PROJECT # 1000390  
 Application # 00450-00000-00884  
 00450-00000-00886

**TRACT G SITEPLAN FOR BUILDING PERMIT**

**PROJECT TITLE**  
 Ventana Square  
 SWC of Tract G and H at Ventana Ranch  
 Albuquerque, New Mexico

**sheet-**  
 A2A

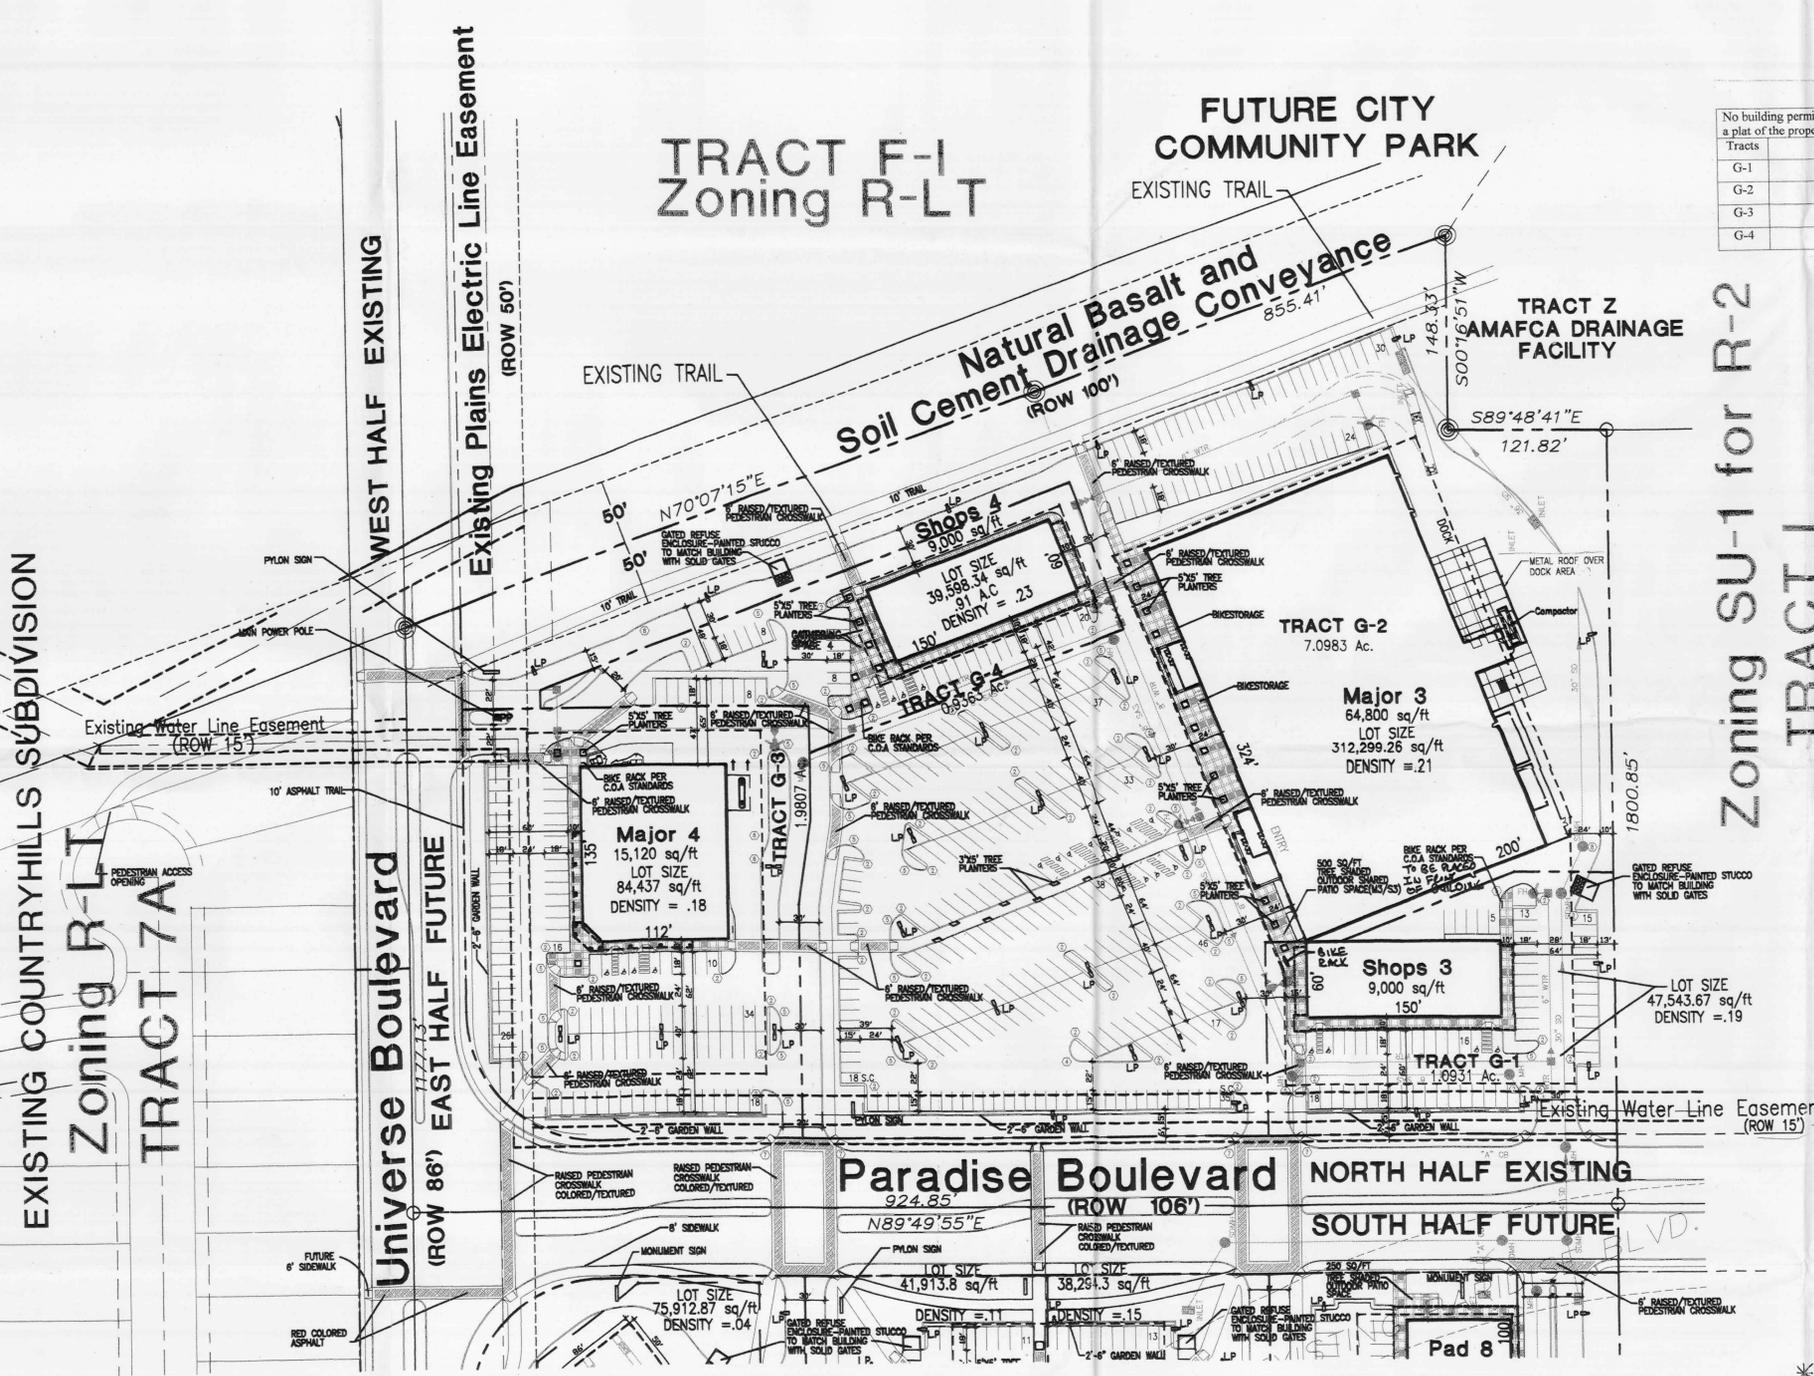
2. The following clarifications and additions to the site development plan submittal shall be addressed:

a. The note regarding alternate uses shall be placed on the landscape plan, gathering spaces, grading and drainage plan, utility plan, and all elevation sheets.

b. Elevations that are also alternate use elevations shall be clearly labeled as such.

a. Speed humps/bumps shall be utilized on both sides of the internal pedestrian crossings of drive aisles or each crossing shall be a raised table, three inches above the drive aisle.

b. Two additional pedestrian links shall be added to Tract G, one from the northwest corner of the site to Major 4 and another connection Shops 4 and Major 3.

c. These paths shall connect to the residential area to the east. There shall be direct pedestrian connections between Pads 7 and 8 and shops 2 at the northeast corner of Tract H. The path which begins in the Gathering Space between Major 2 and Shops 2 and then travels around the backside of Shops 2 shall connect to pads 7 and 8. These paths shall connect to the residential area to the east.

d. Adequate bicycle parking shall be shown at Shops 5 and Pads 4 and 6.

5. The height of the lighting poles shall be reduced to 24' maximum and a maximum of 20 feet high within 300 feet of a residential zone.

a. The major east-west, pedestrian walkway between Majors 3 and 4 on Tract G shall have additional shade trees planted along its entire length similar to the major east-west pedestrian walkways on Tract H.

b. The entire, eastern setback of Lot UG-4 shall be increased to at least ten feet to allow for a ten-foot-wide landscaping buffer between the subject site and the adjacent, residential zoning to the east.

d. Screen or garden walls, 2 1/2' - 3' feet high with colors and texture that are contextual with the building materials shall be located along all parking areas that front on a roadway or street.

a. The color of the roof tiles shall be specified.

b. The color of the building cornices shall be specified.

c. All loading dock and receiving areas shall be visually screened with walls and roofs that integrate with the building architecture; roofs over loading docks are limited to those docks facing residential zoning.

d. In addition to a ten foot landscape buffer, the eastern edge of Lot UG-4 shall have a minimum eight foot high, solid wall along its entire length.

e. Variations in the surface of the exterior walls and/or display windows as per the additional design requirements shall be added to the building elevations. The areas between the stucco control joints shall have the same medium tan color as the CMU base.

f. Colors and materials of the signs shall match those of the buildings and be called out on the detail diagrams.

g. Freestanding signs are limited to a maximum height of 16 feet.

a. The applicant shall take the trail design and any landscaping adjacent to Paseo del Norte to the Parks and Recreation Department for review and approval prior to final DRB approval.

b. The 10' asphalt trail along universe, outside the right of way but within a utility easement shall be clarified as either a trail or a sidewalk. In its northern section, between Paradise and the channel, there shall be a 3' separation between the trail and the curb.

a. The entrance in the immediate proximity of Major 4 must be reconfigured and channelized to better define traffic patterns and placement of control devices.

c. Location of walls, fences, refuse containers and signs must meet the clear sight distance requirements for adjacent streets and internal circulation aisles.

e. The site plan must identify surrounding uses and provide dimensions where appropriate, i.e., structures, streets, medians, drive aisles, parking spaces, walls, signs, etc.

g. Location and dimension of proposed fire lanes must meet Fire Code requirements as per the DPM.

k. The utility plan will address potential conflicts, including: The sanitary outfall appears to be routed through a storm sewer manhole. Status operation and maintenance responsibilities for the "temporary lift station" must also be addressed. These issues must be resolved prior to DRB action.
